GOLDEN GLOW FARMS SUBDIVISION, **RESUBDIVISION OF LOTS 7 - 9**

APPLICATION NUMBER 6 DATE April 2, 2015
APPLICANT Golden Glow Farms Subdivision, Resubdivision of Lots 7-9
REQUEST Subdivision

DETAIL SITE PLAN

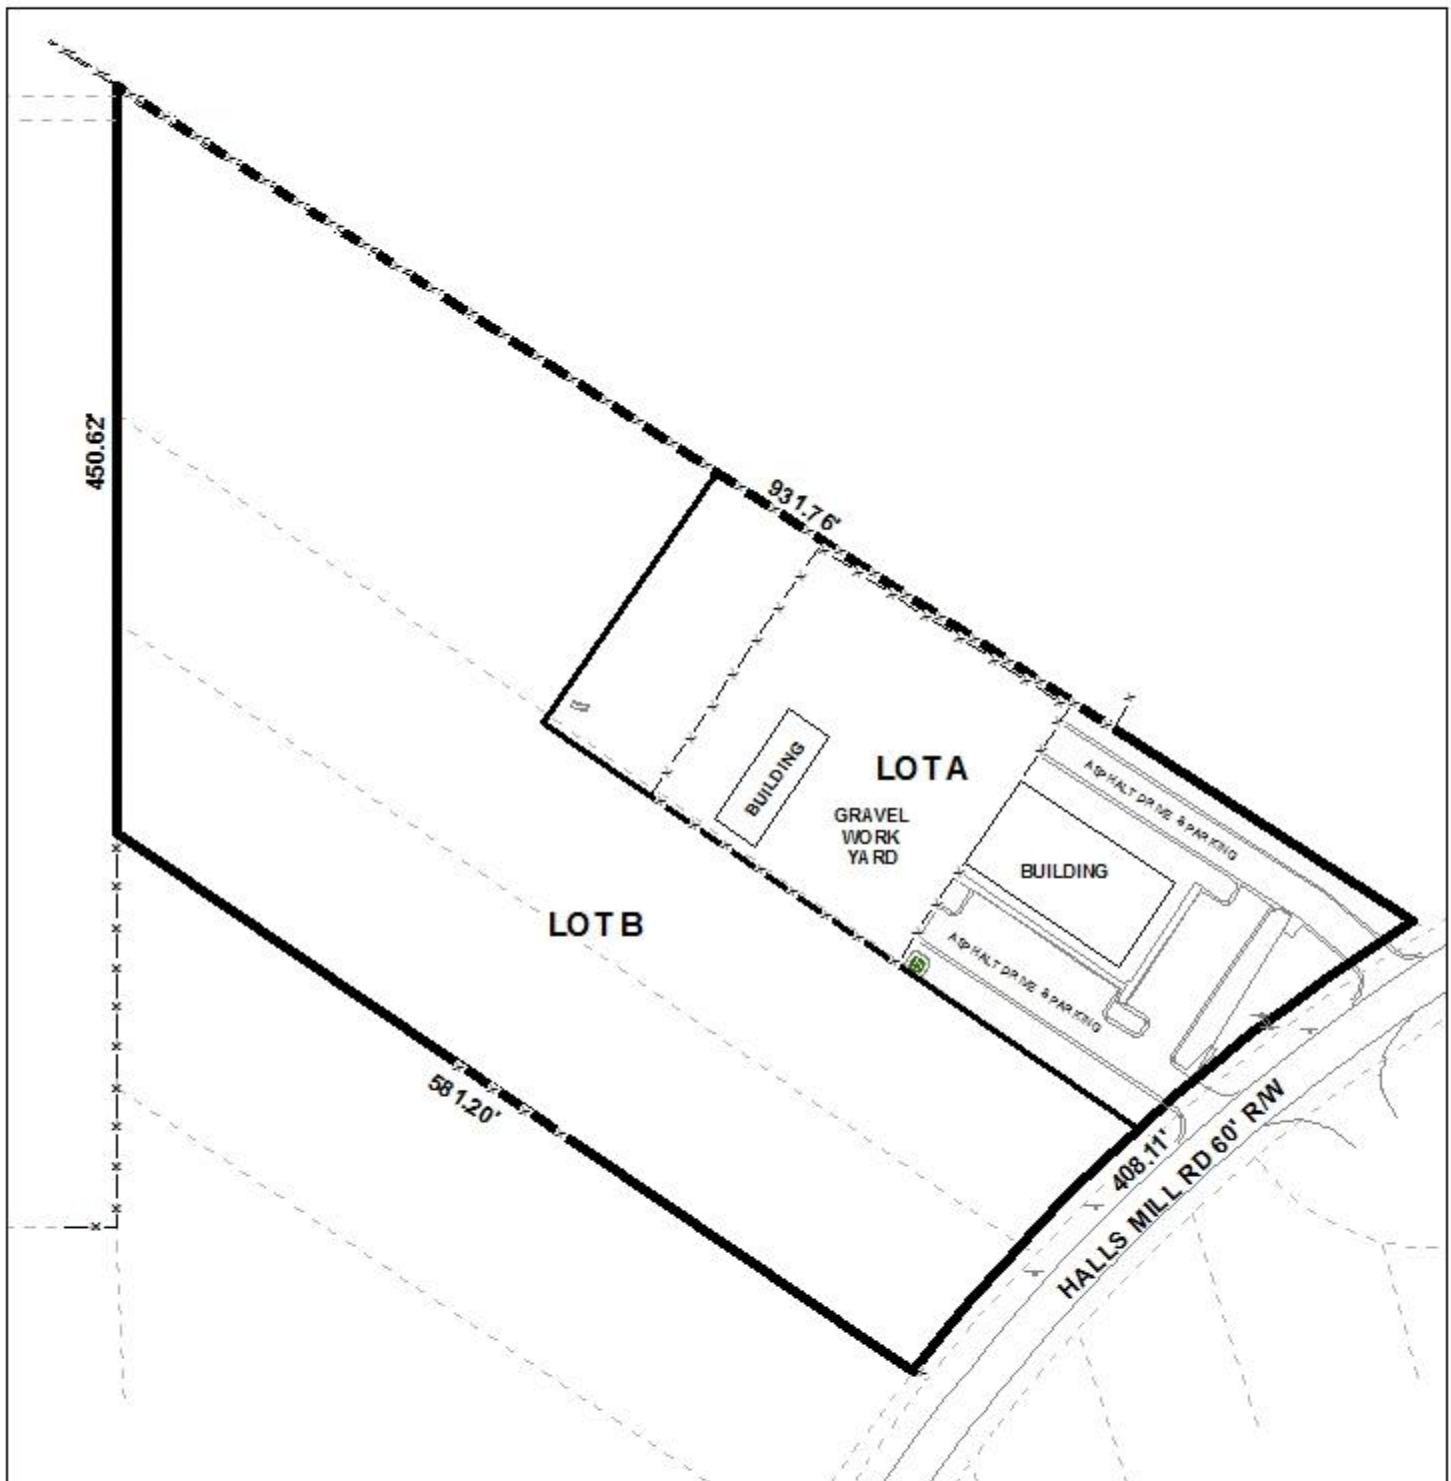
The site fronts onto Halls Mill Road, a collector street, with a required 70' right-of-way and a current 60' right-of-way. Although not indicated on the plat, the subject site scales to have a current and compliant 35' to the centerline of Halls Mill Road. Therefore, the plat should be revised to either indicate a current and compliant 35' from the centerline of Halls Mill Road, or dedication should be required to provide 35' from the centerline of Halls Mill Road. As a means of access management, a note should be required on the Final Plat stating that Lot A is limited to

its existing curb cuts and Lot B is limited to one-curb cut, with size, location and design to be approved by Traffic Engineering and conform to AASHTO standards.

Each lot meets the minimum area and width requirements of the Subdivision Regulations. The plat should be revised to label each lot with its size in both square feet and acres, after any required dedication, or a table should be furnished on the Final Plat providing the same information. The plat should also be revised to illustrate the 25' minimum building setback line along Halls Mill Road, as measured from any required dedication.

Lot B would exceed the maximum depth-to-width ratio of Section V.D.3. of the Subdivision Regulation; however, there have been other Subdivisions in the area approved by the Commission with similar situations. Therefore, a waiver of that section would be in order.

- 1) revision of the plat to either indicate a current and compliant 35' from the centerline of Halls Mill Road, or dedication to provide 35' from the centerline of Halls Mill Road;

- 2) placement of a note on the Final Plat stating that Lot A is limited to its existing curb cuts and Lot B is limited to one-curb cut, with size, location and design to be approved by Traffic Engineering and conform to AASHTO standards;

- 3) revision of the plat to label each lot with its size in both square feet and acres, after any required dedication, or the furnishing of a table on the Final Plat providing the same information;

- 4) revision of the plat to illustrate the 25' minimum building setback line along Halls Mill Road, as measured from any required dedication;
- 5) subject to the Engineering comments: *(The following comments should be addressed prior to submitting the FINAL PLAT for acceptance and signature by the City Engineer: A. Provide the Surveyor's, Owner's (notarized), Planning Commission, and Traffic Engineering signatures. B. Add a note that sidewalk is required to be constructed, and/or repaired, along the frontage of each lot, or parcel, at time of development, unless a sidewalk waiver is approved. C. Provide a copy of the Final Plat along with the original when submitting for City Engineer signature.);*
